Subject: East Altamont Energy Center Application for Certification
Data Request Response Set #1 (01-AFC-04)

East Altamont Energy Center
Data Requests and Responses (01-AFC-4)
Set #1

EAST ALTAMONT ENERGY CENTER DATA REQUEST AND RESPONSE SET #1 (01-AFC-4)

Technical Area: Visual Resources

Figure 7.2a

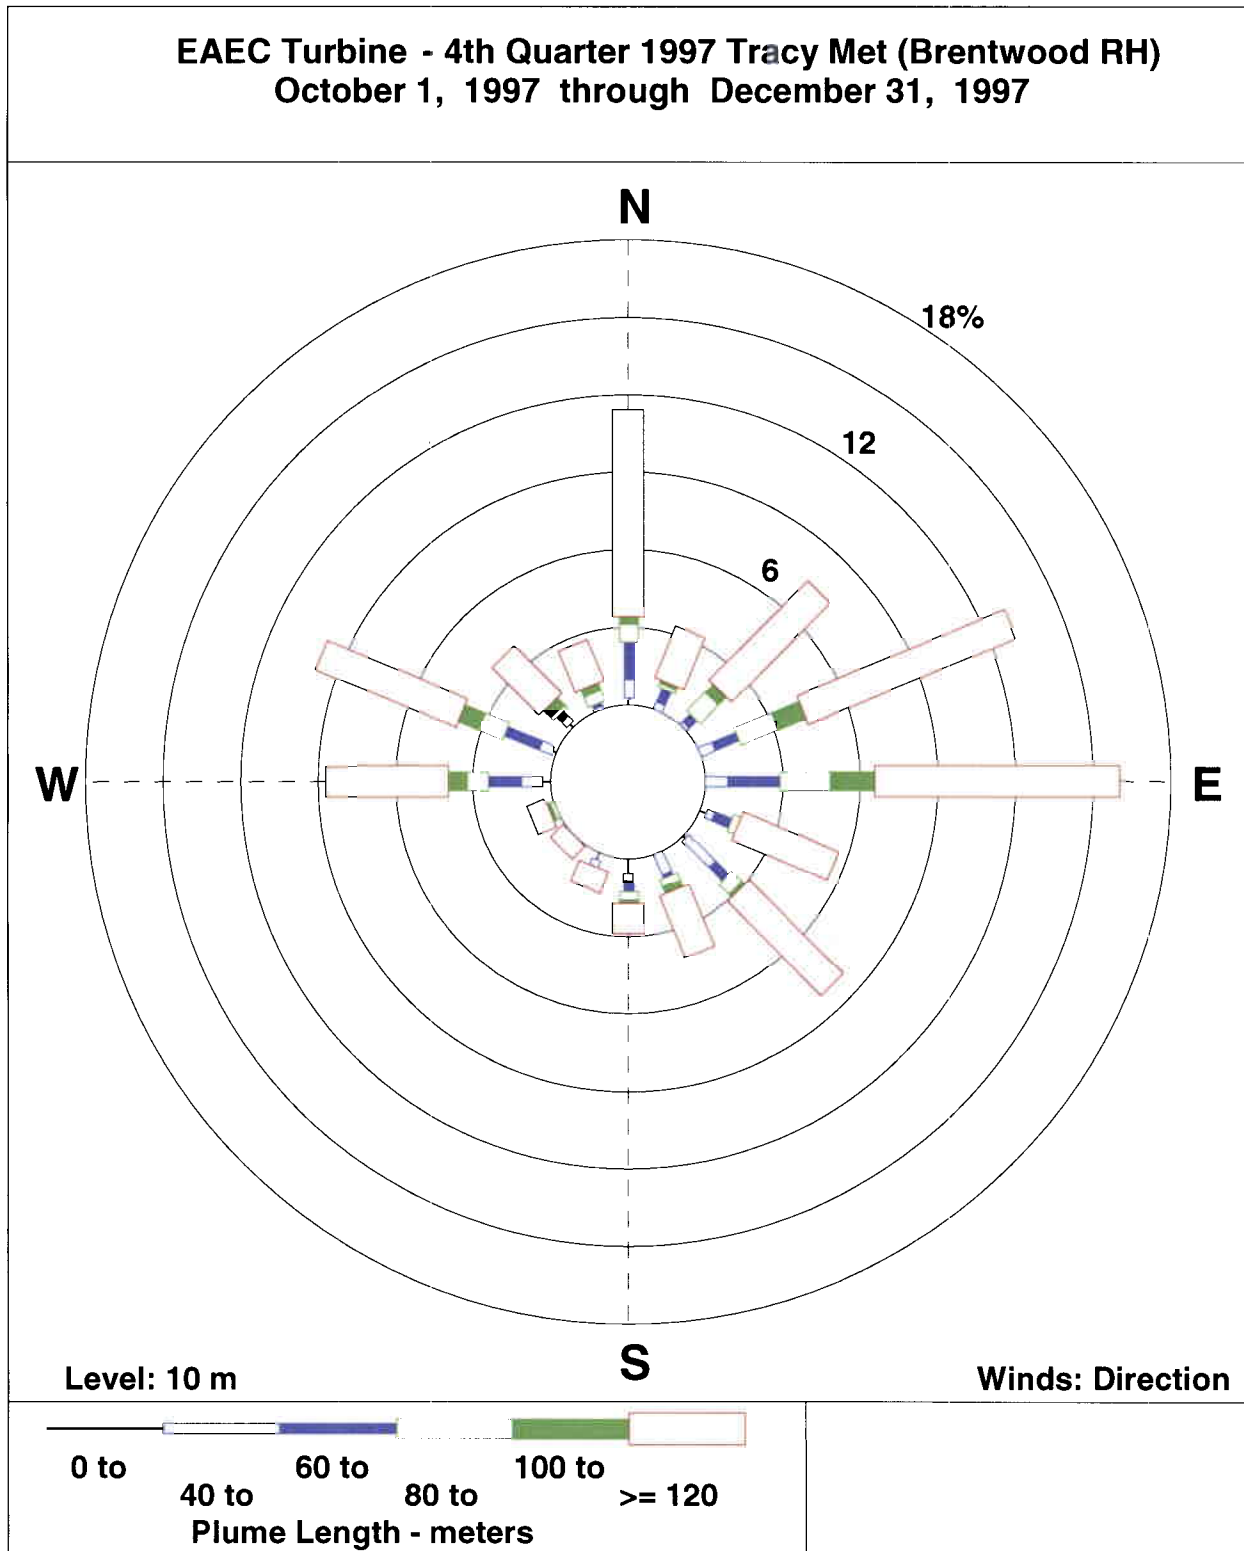
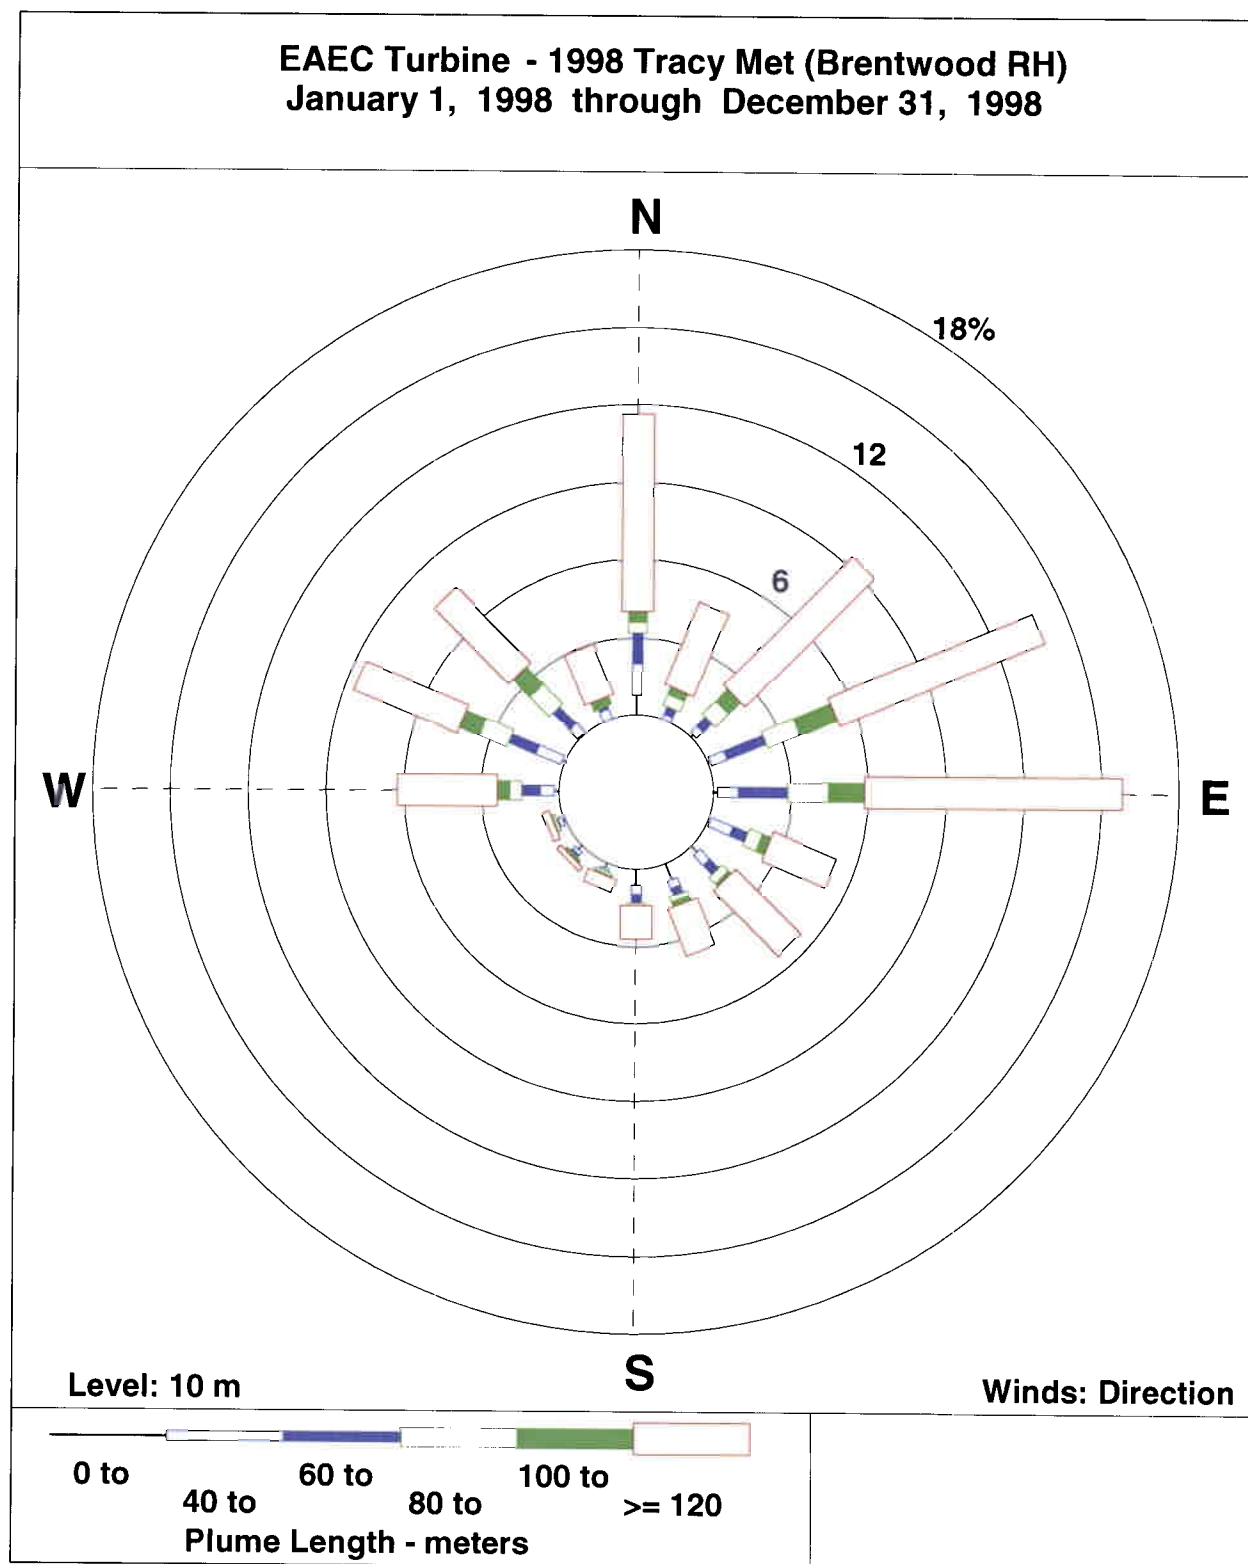
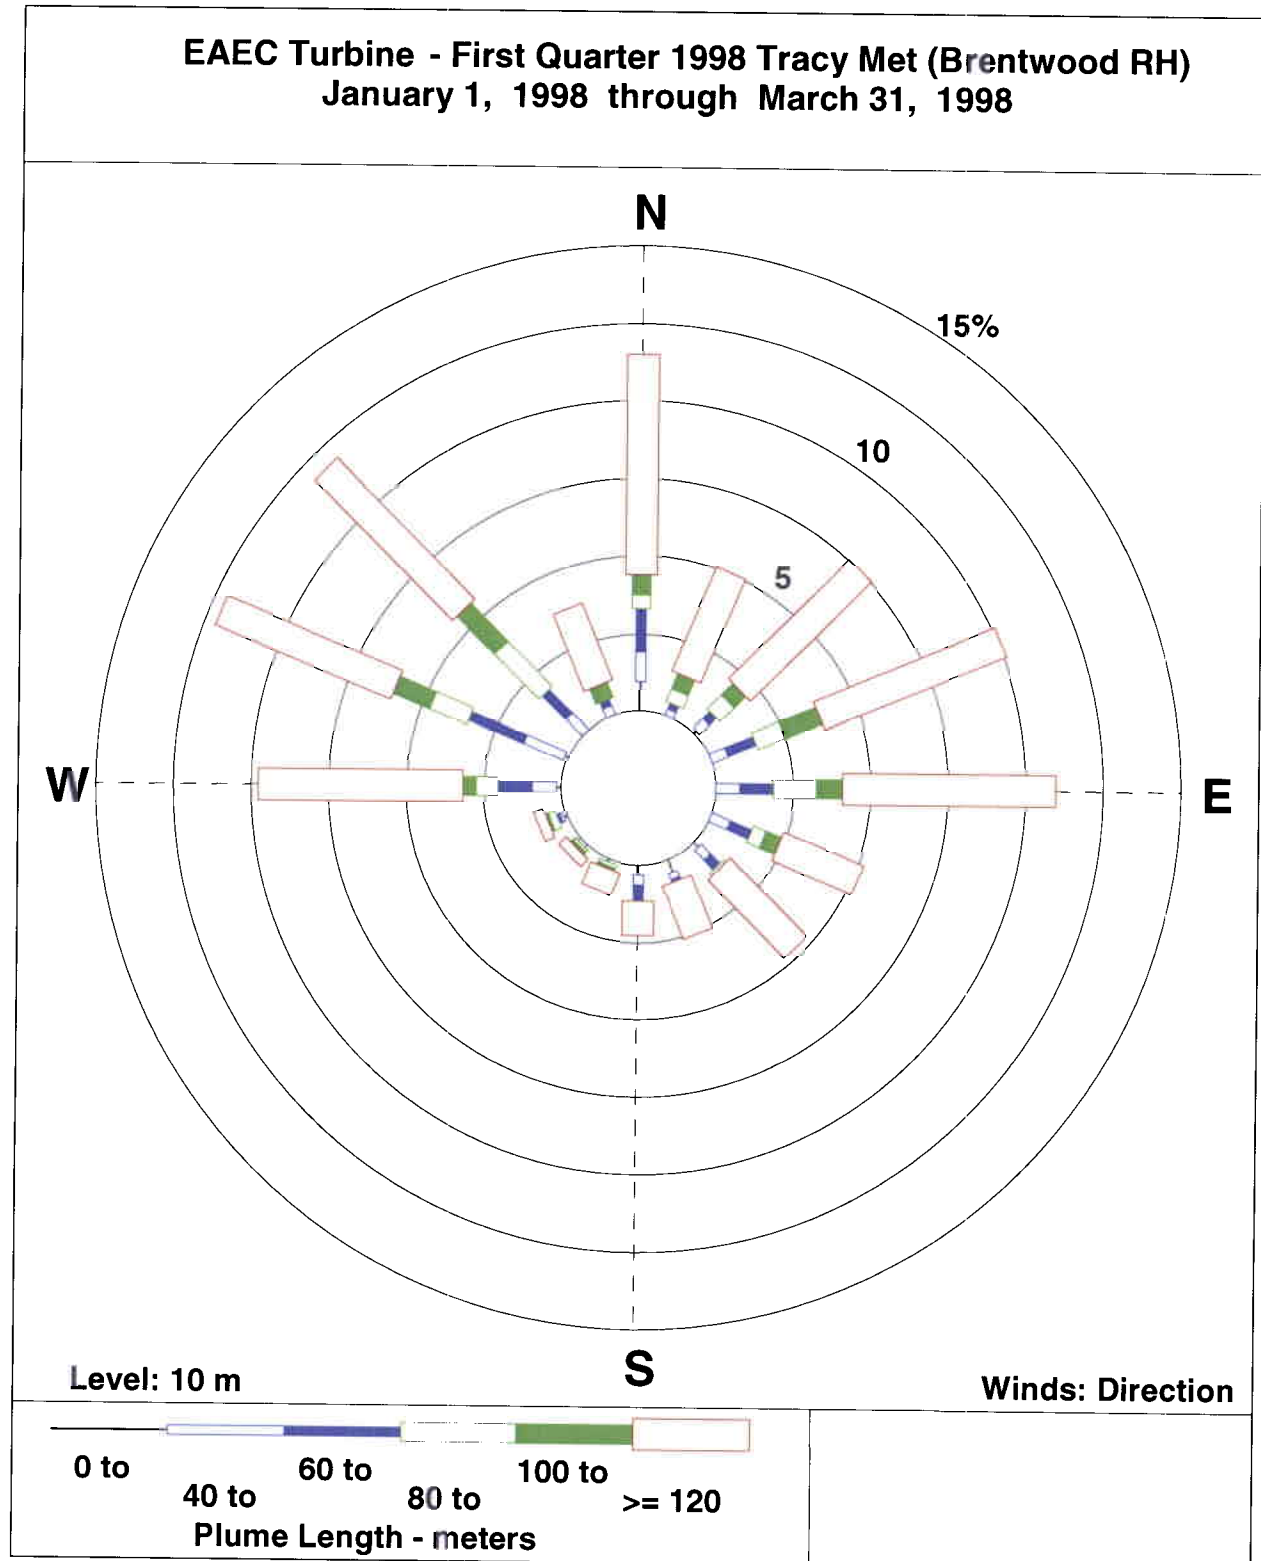
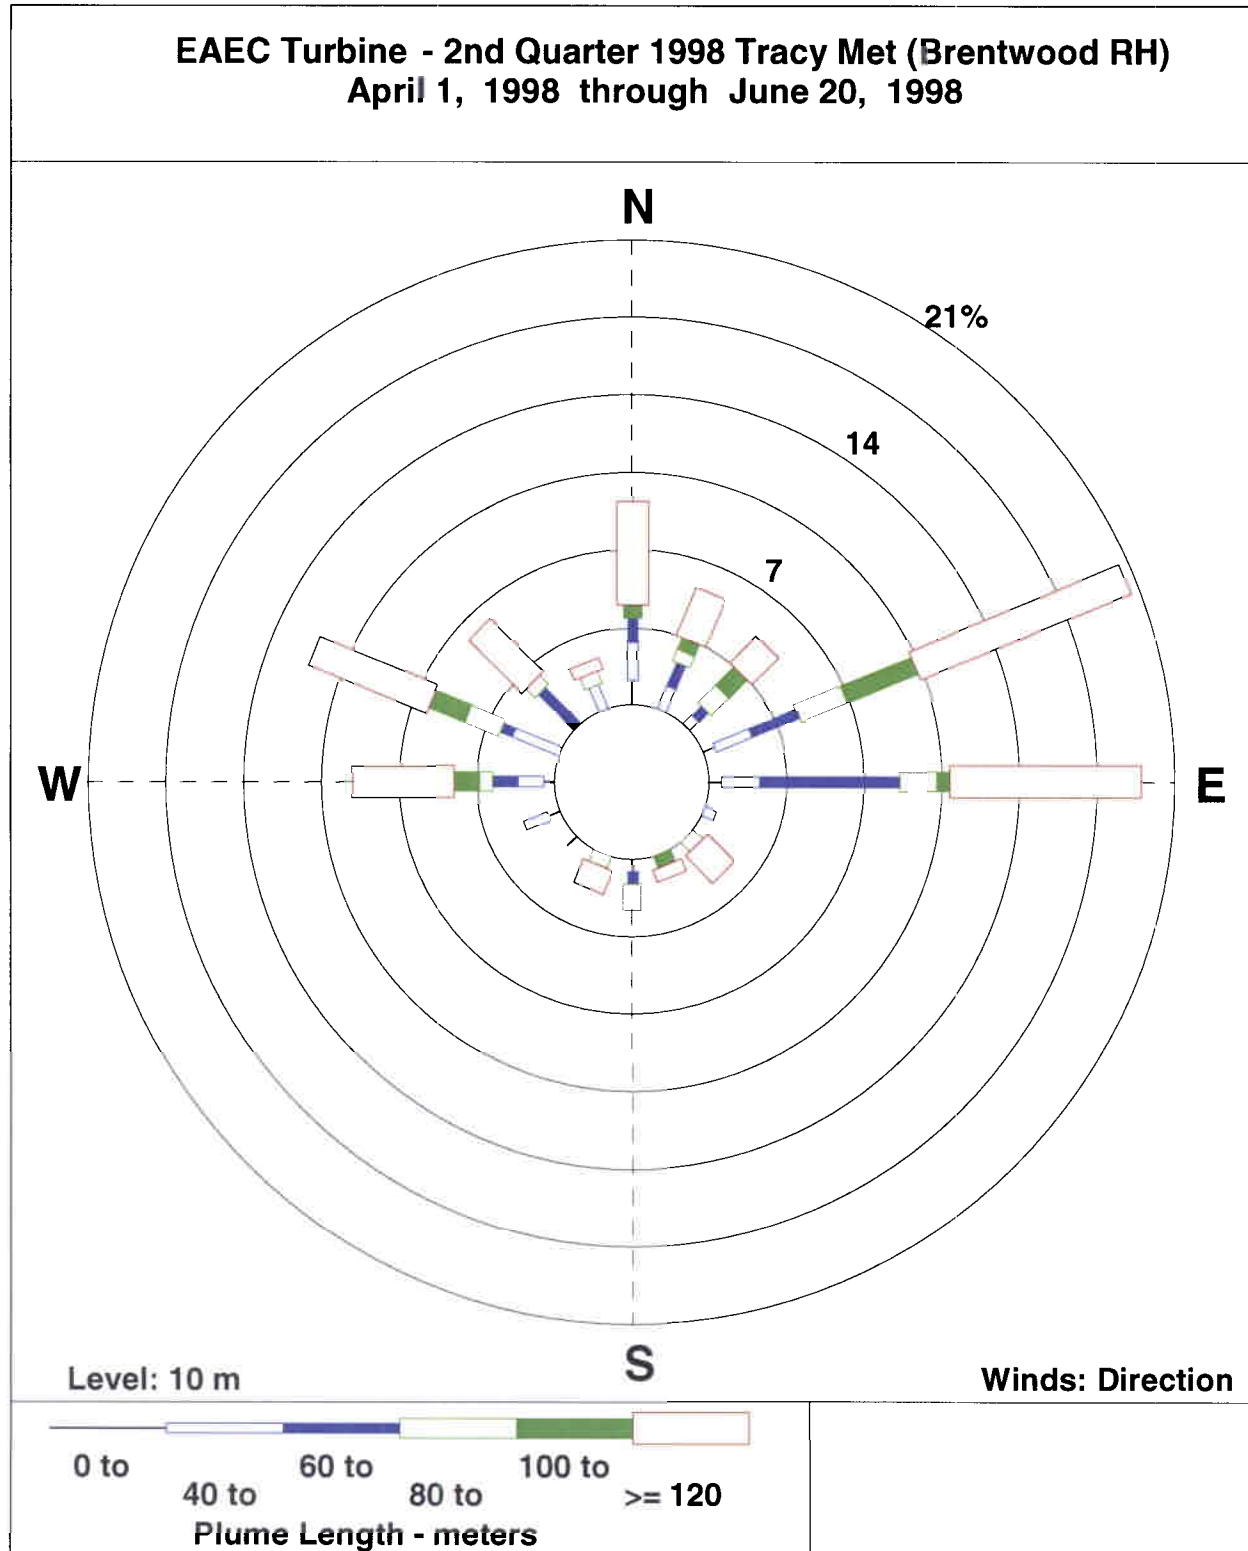
- a. The total number of daylight hours annually and seasonally;

Response: Table VIS-7.1 shows the number of hours per year that there is the potential for formation of a visible water vapor plume of various lengths from each HRSG stack. The analysis assumes that each HRSG is operated for 8,760 hours per year. During the hours between 6 a.m. and 8 p.m., the units are assumed to operate at full load with duct firing and power steam augmentation; during all other hours, the units are assumed to operate at full load, but without duct firing or power steam augmentation. The analysis was performed for each of the three years of meteorological data available.

A seasonal distribution of these hours is presented in the plume roses included as Figures VIS-7.1a through VIS-7.3e.
